Recall Bulletin

PRODUCT SAFETY RECALL

SUBJECT: Compressed Natural Gas (CNG) Fuel Tank Shut-Off Solenoid Connector

MODELS: 2011-2013 Chevrolet Express
2011-2013 GMC Savana
Equipped with CNG Fuel System

3457040

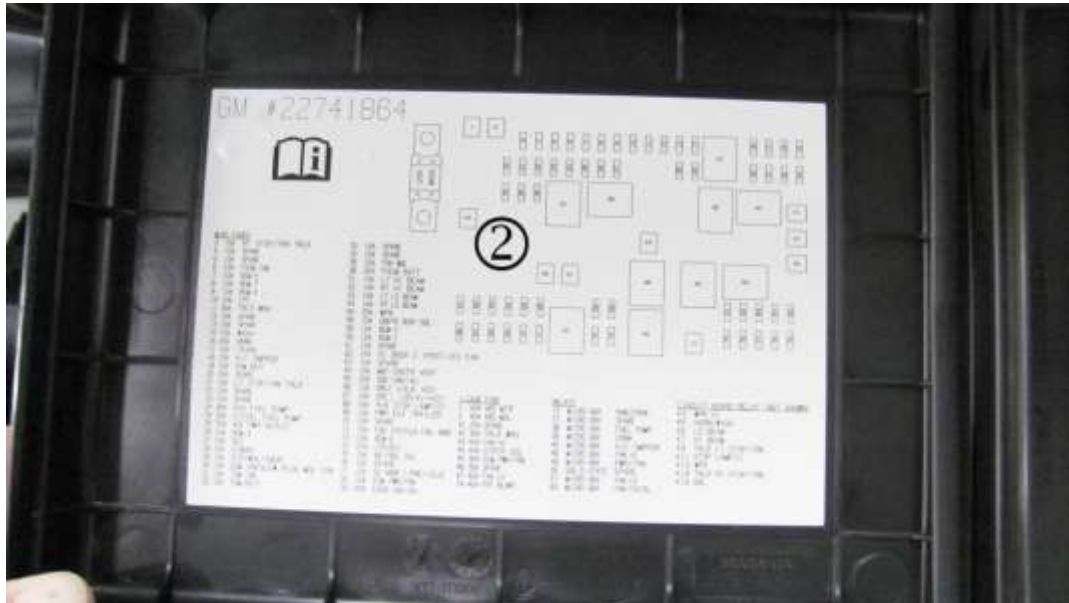
4. Locate the 30-amp fuel pump fuse and remove it from the underhood electrical center or junction block (1). Refer to number 24 on the fuse and relay label, which is located on the underside of the underhood electrical center cover.
5. Discard the 30 amp fuel pump fuse.

- If the vehicle is equipped with a 4-tank system (RPO UFP), install a 7.5-amp fuse.
- If the vehicle is equipped with a 3-tank system (RPO UFM), install a 5-amp fuse.

3457050

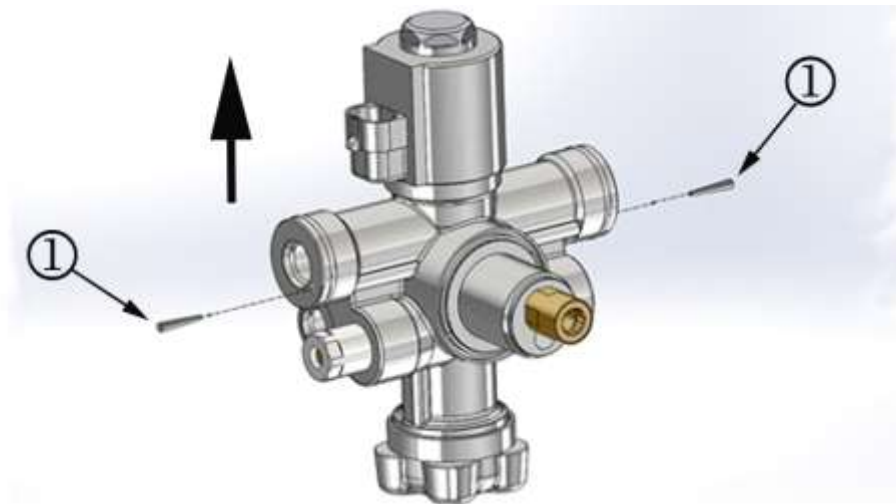
10. Apply a thin layer of Parker lube on the upper HPL solenoid retaining nut seal on both sides of the seal.
11. Place new seal in groove in nut.
12. Install the HPL solenoid coil retaining nut. Tighten the retaining nut to **6.5 Nm (57.5 lb-in)**.
13. Connect the HPL solenoid harness connector.

3530550

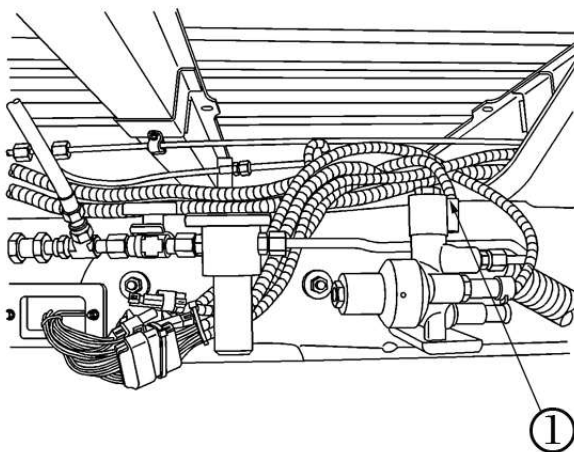
Connector must point upward.

15. Install two CNG cylinder tank valve plugs (1). Refer to the illustration. This step can be skipped for 2013 model year vehicles, which have plugs already installed.
16. Open the manual shutoff valve for the midship tank.

3457059

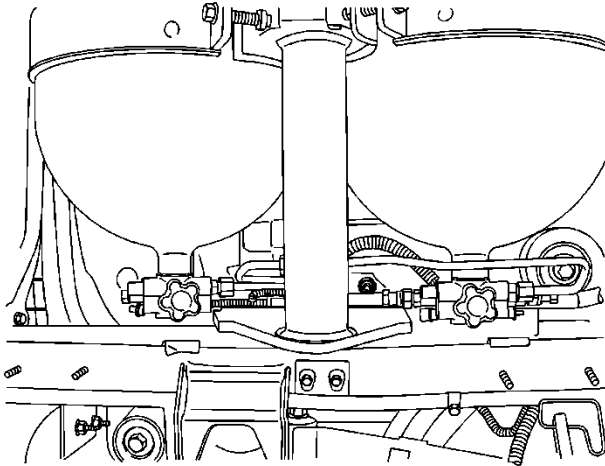
1. Disconnect the high pressure lockoff (HPL) solenoid electrical connector (1).
2. Inspect HPL solenoid harness connector for corrosion or contamination.
 - If corrosion or contamination is present, replace the connector with **GM P/N 13586114**. Refer to GM service instructions included with connector and *Splicing Copper Wire Using Splice Sleeves* in SI.
 - If corrosion or contamination is NOT present, proceed to step 3.
3. Remove the CNG High Pressure Regulator. Refer to *CNG High Pressure Regulator Replacement* in SI.

4. Install the new CNG High Pressure Regulator contained in CNG High Press Regulator Kit 19330022. Note that this kit is also used to perform the required repair for safety recall 14321. Refer to *CNG High Pressure Regulator Replacement* in SI.
5. Connect the HPL solenoid electrical connector.

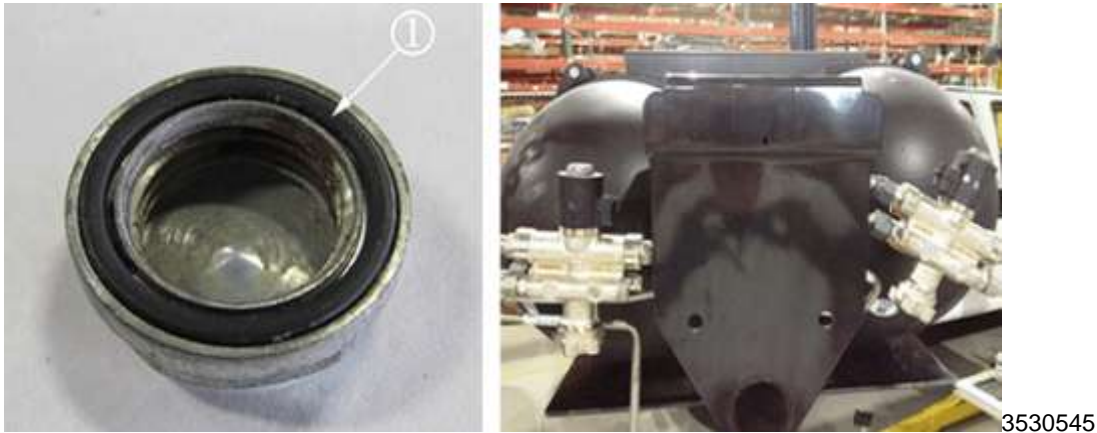
8. Replace lower HPL solenoid coil seal (1).
9. Using the reference mark created in step 4, install a new HPL solenoid coil on the aft assembly. Turn the forward coil 180 degrees to face the aft tank assembly.

Note: Both HPL solenoid connectors should face each other after installation.

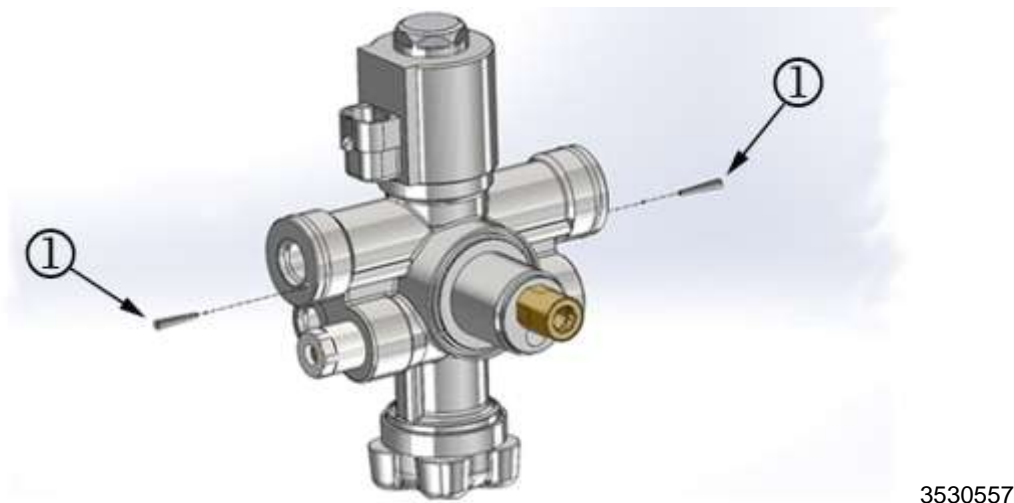
14. Route the forward HPL solenoid harness (1) over the top of brace (2) so that the connector feeds directly into the solenoid.
15. Connect the HPL solenoid harness connector.
